Project: St. Bernard Parish – Public Library  
Judge Perez Drive  
St. Bernard Parish, LA  
Parish Project No. SBPG/NPL  
ABM Project No. 201803  
MBA Project No. 11884

Subject: REQUEST FOR INFORMATION

**RFI Number:** 78  
**RFI Title:** Pull Wire Location

SHEET TITLE  
 FLOOR PLAN - POWER & SPECIAL SYSTEMS

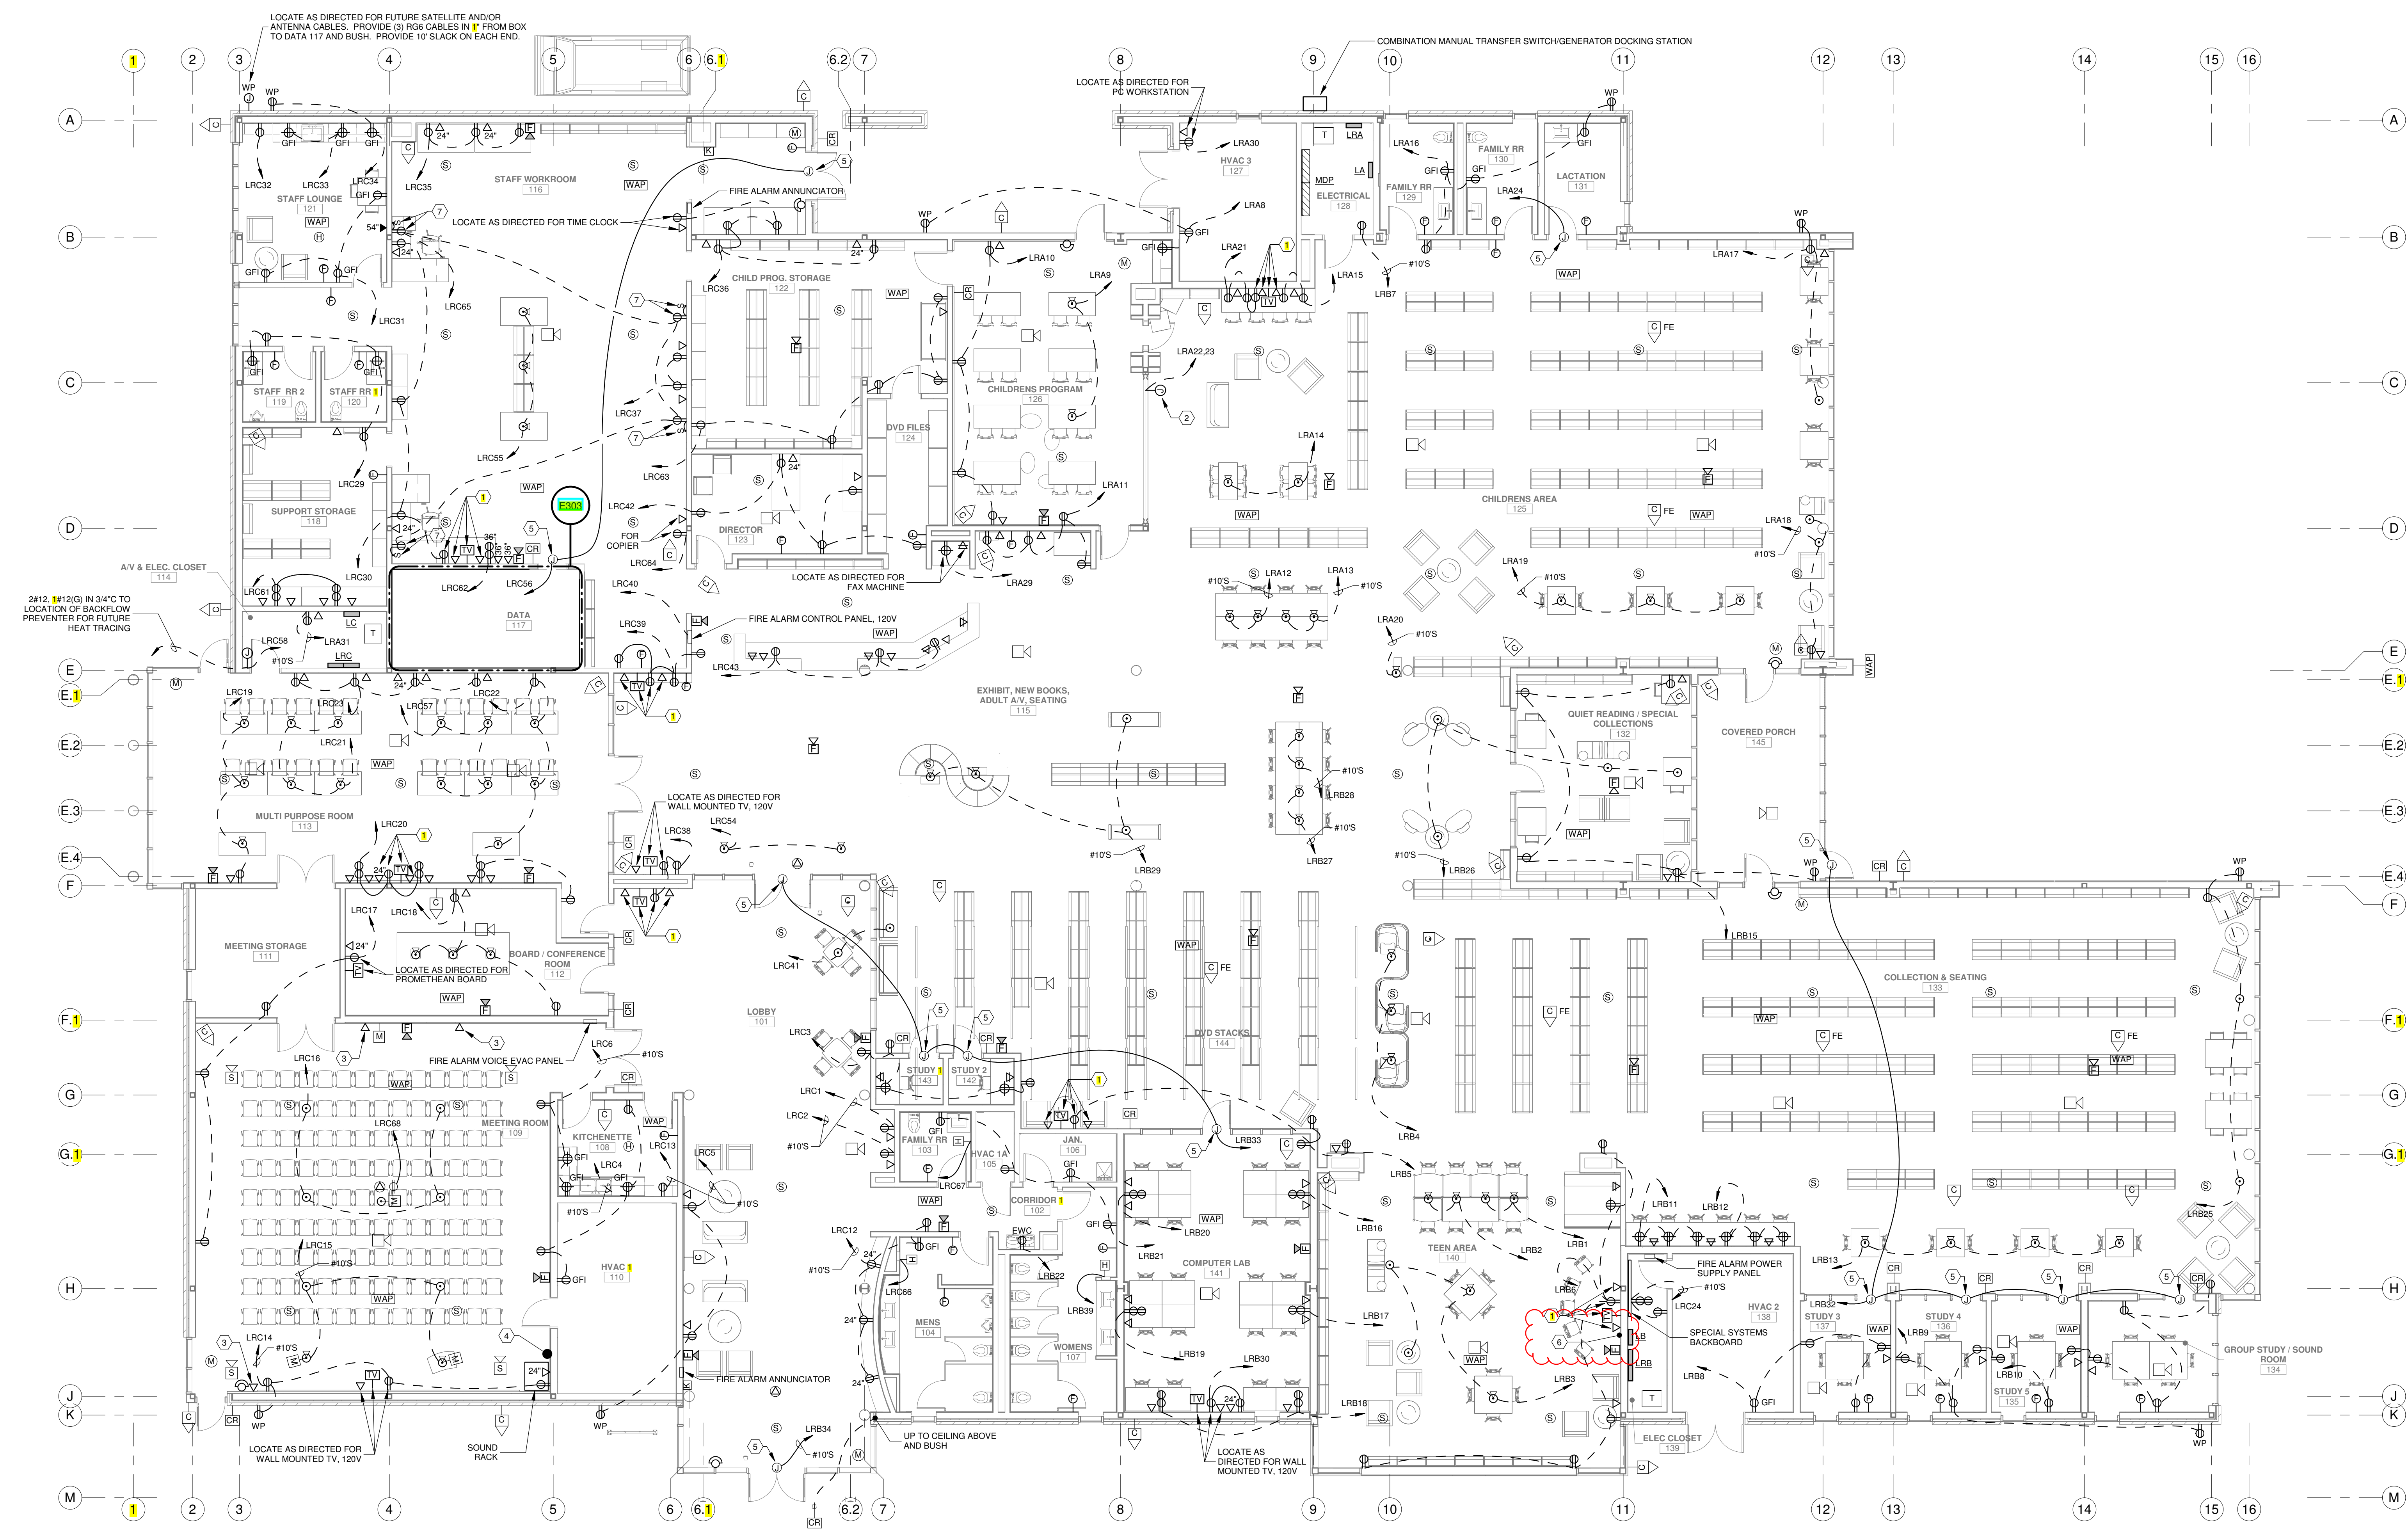
Note 6 on E201 calls for a pull wire between locations. Only one location is provided. Please provide the 2nd location to pull wire.
